Z-9 (2017) West Tract

Z-9 (2017) East Tract

PETITION NO: Z-9

STORMWATER MANAGEMENT COMMENTS

**Corner Road West Tract
R-20 OSC Plan**

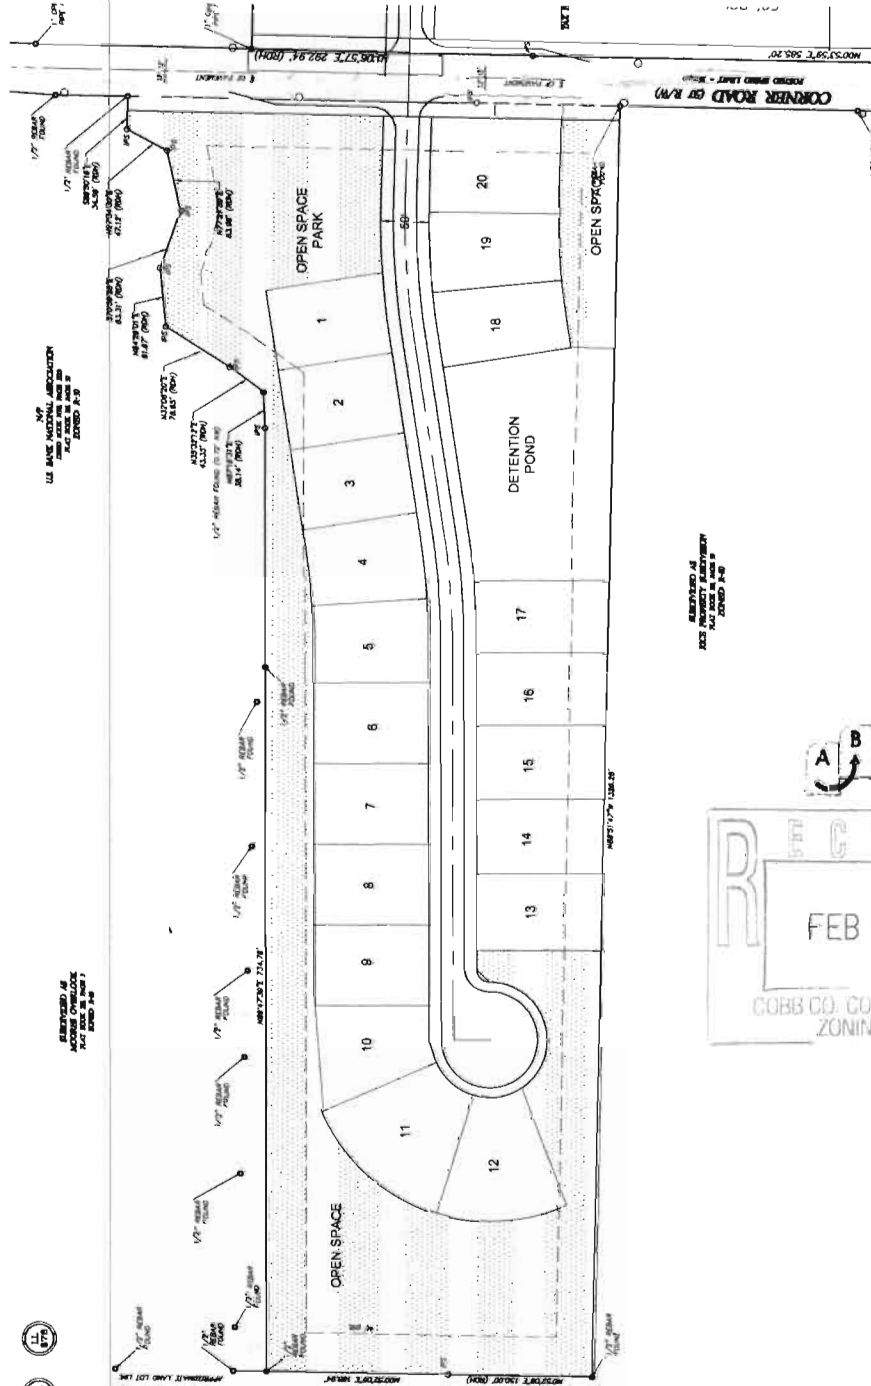
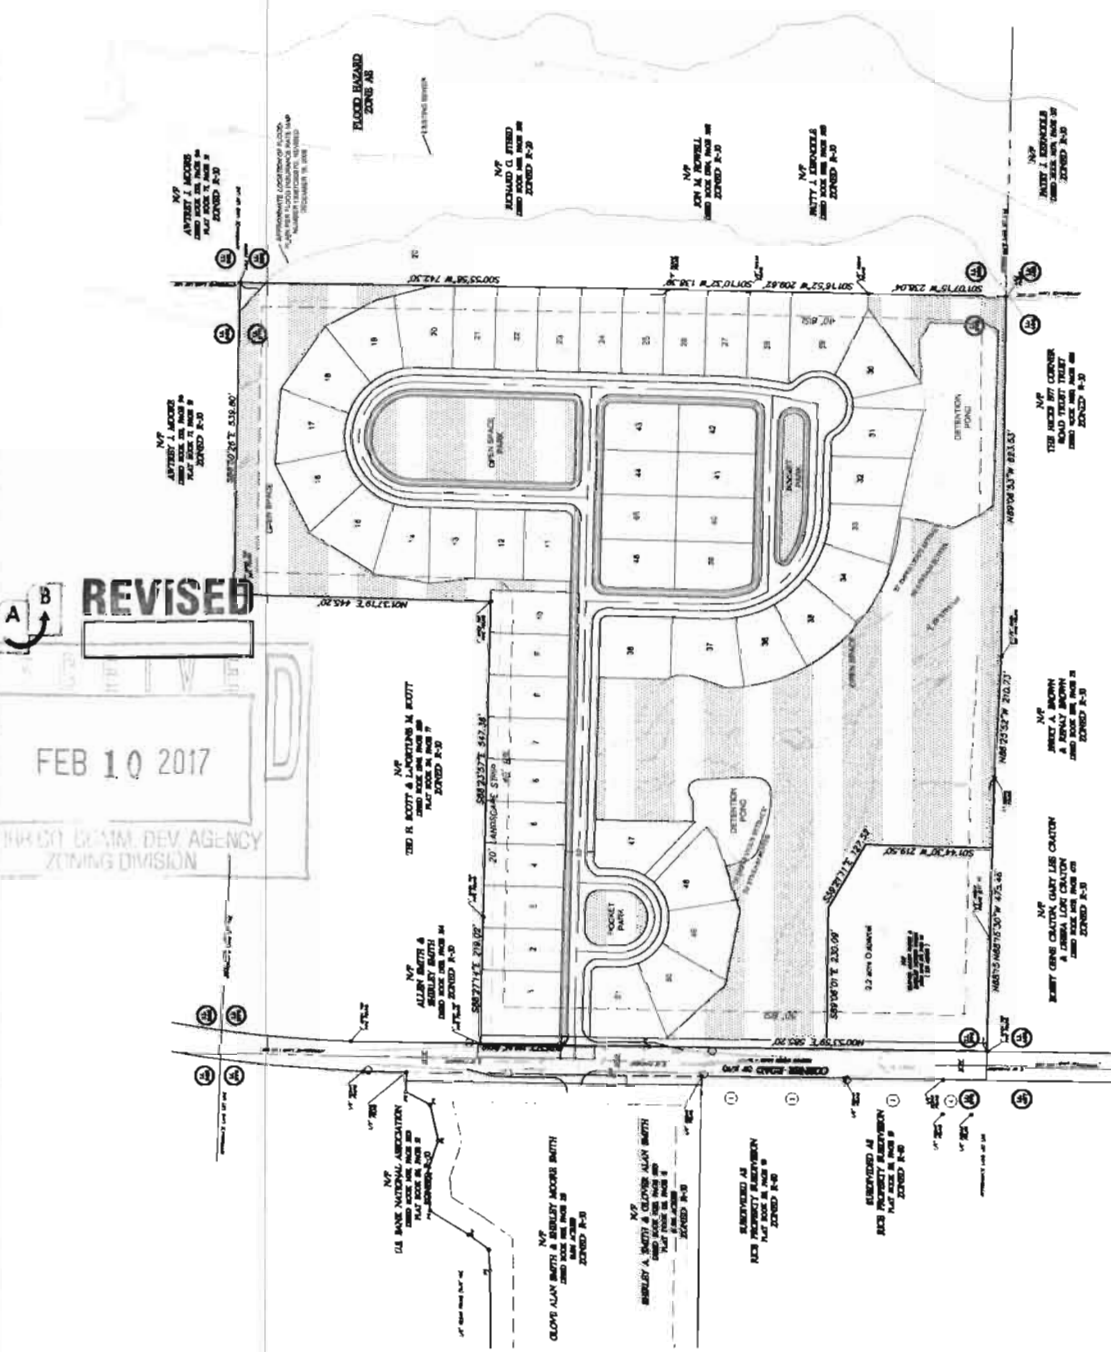
The portion on the west side of Corner Road has 4.02 acres set aside for open space and the portion on the east side of Corner Road has set aside 10.46 acres as open space. Open space parks are indicated on both tracts.

The applicant is requesting a variance for 5-foot side setbacks with 15 feet between houses.

Recommend entrance to Corner Road East Tract directly align with the entrance to Corner Road West Tract per Development Standard 401.10.

As necessitated by this development, recommend Corner Road access include deceleration lane and left turn lane for both the East and West Tract. Recommend location and design be determined during plan review, subject to Cobb County DOT approval.
